**Proposed EV Mobility City with Ancillary Staff Quarters and
Talent Accommodation at Various Lots in D.D. 51 and
Adjoining Government Land, Fanling
(Application No. Y/FSS/20)
- Further Information No. 3 -**

In response to the departmental comments from relevant Government Departments, Further Information ("FI") No. 3 has been prepared. This FI submission consists of:

**S.12A Amendment of Plan Application
Proposed EV Mobility City with Ancillary Staff Quarters
and Talent Accommodation at Various Lots in D.D. 51 and
Adjoining Government Land, Fanling**

(Application No. Y/FSS/20)

**Appendix 3.4 Extracted from Engineering Feasibility Study Report for
Proposed Public Housing Development at Area 48, Fanling
(PHD48)**

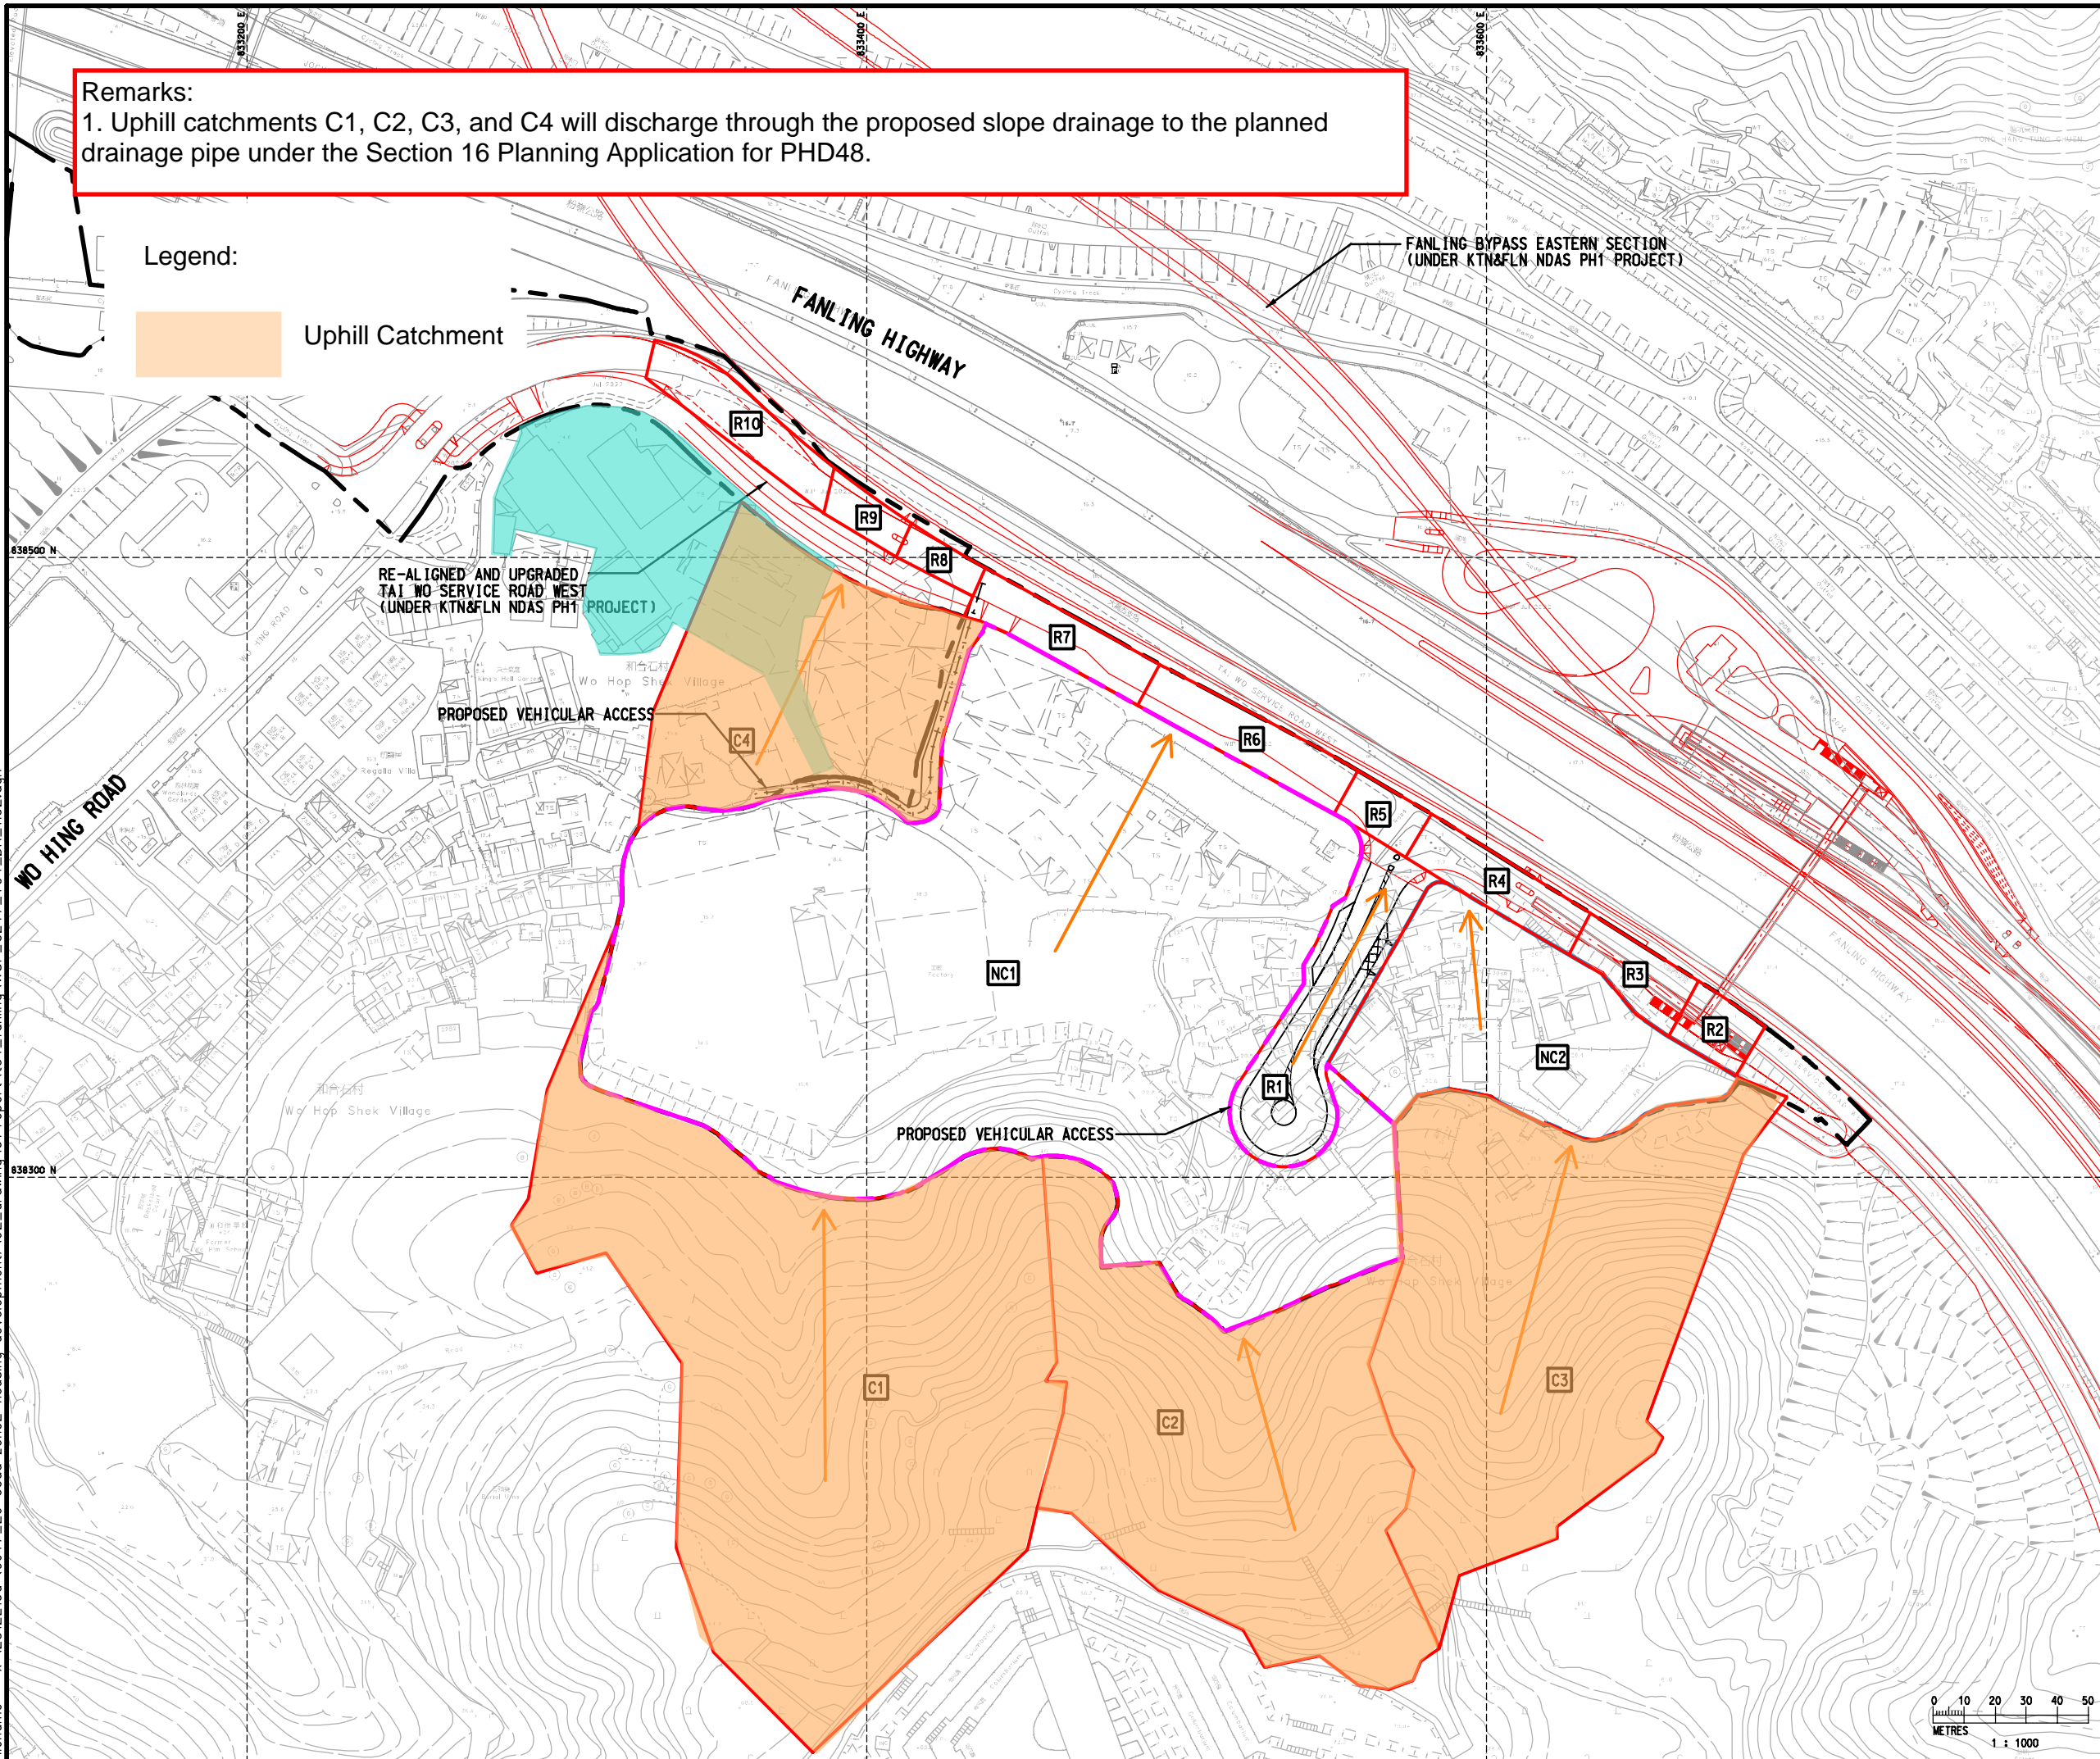
Comments	Responses
<p>the adjacent catchment areas or adversely affect the existing drainage system.</p>	
<p>3. Appendix 3.4 and Section 2.1.3:</p> <ul style="list-style-type: none"> • Please indicate the concerned "uphill catchment" and associated slope drains in Appendix 3.4. • Please provide more detailed description of the proposed internal drains within the site (e.g. alignment, dimension, catchment delineation, capacity check, discharge points, etc. • Please include site photos of the existing drainage system within the site for our reference. 	<ul style="list-style-type: none"> • The uphill catchment and associated slope drains have been indicated in Appendix 3.4. • A peripheral drainage channel has been proposed within the Application Site. The proposed alignment is presented in Figure 2.1, and the corresponding hydraulic calculations have been updated and provided in Appendix 2.1. • According to the site survey, there is no drainage system observed within the Application Site. Please refer to the newly added Appendix 1.1.

- 2.1.4 According to the preliminary drainage impact assessment of the Approved Section 16 Planning Application for PHD48, a slope drains will be proposed to receive the surface runoff from uphill catchment (shown in **Appendix 3.4**). Therefore, it is anticipated that there is no surface runoff from uphill catchment will be flow into the Application Site.
